Evaluation of Regulations for the Expansion of the Flower Garden Banks National Marine Sanctuary Expansion

White Paper

October 2016

This is a publication of the Gulf of Mexico Fishery Management Council Pursuant to National Oceanic and Atmospheric Administration Award No. NA15NMF4410011.

Figure 20. Example of using the BOEM “no activity zone” to delineate a “no bottom tending gear zone.”

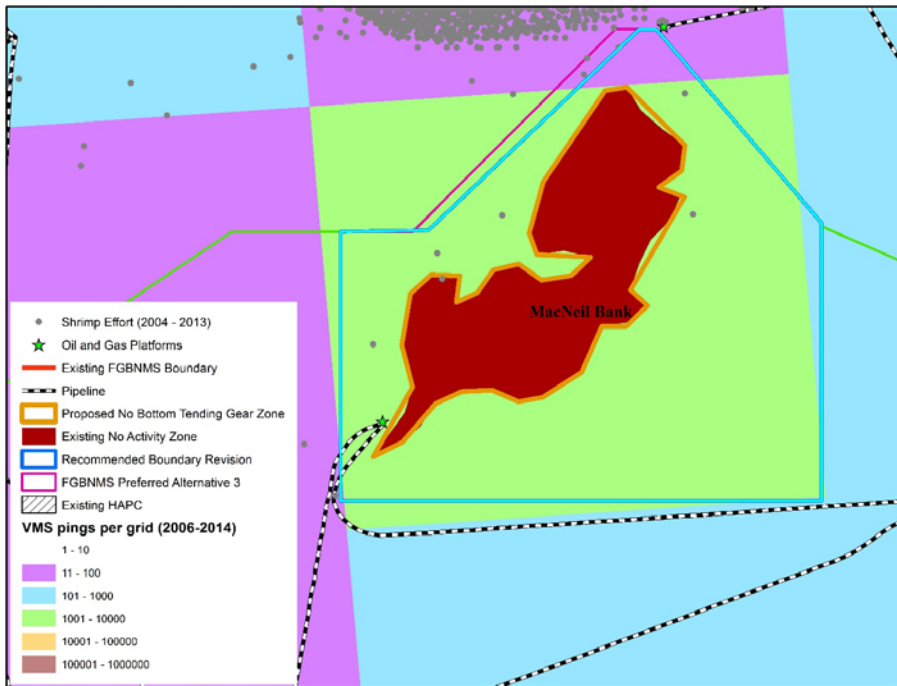
Many of the recommendations stem from having a “tiered” approach, or certain fishing activities allowed within the expansion of the FGBNMS. As it was suggested that the BOEM “no activity zones” coincide with the “no bottom tending gear zones” (Figure 20). Nearly the entirety of the proposed boundary of the Preferred Alternative 3 expansion of FGBNMS of MacNeil Bank is a heavily used area for reef fish (VMS data.) Thus, the closure of this area would greatly affect the fishermen in this region. Supporting a “no bottom tending gear zone” within the boundary while allowing anchoring in soft sediment or fishing with bottom tending gear outside of the no activity zone would minimally affect the fishermen that rely on these areas while maximizing protection for the hardbottom reef resources. Additionally, limiting the footprint of trawling outside of these areas will protect the reef from sediment plumes.

Tier 1- inside the “no bottom tending gear zones

- Fishing only by hook and line, no anchoring

- Requires a special endorsement from the FGBNMS

Tier 2- outside the “no bottom tending gear zone” and inside the Council recommended boundary of the expansion of FGBNMS for MacNeil Bank (Preferred Alternative 3)

- Anchoring using a soft sediment specific anchor (e.g. Danforth anchors, etc)

- No bottom trawling, traps, or dredges
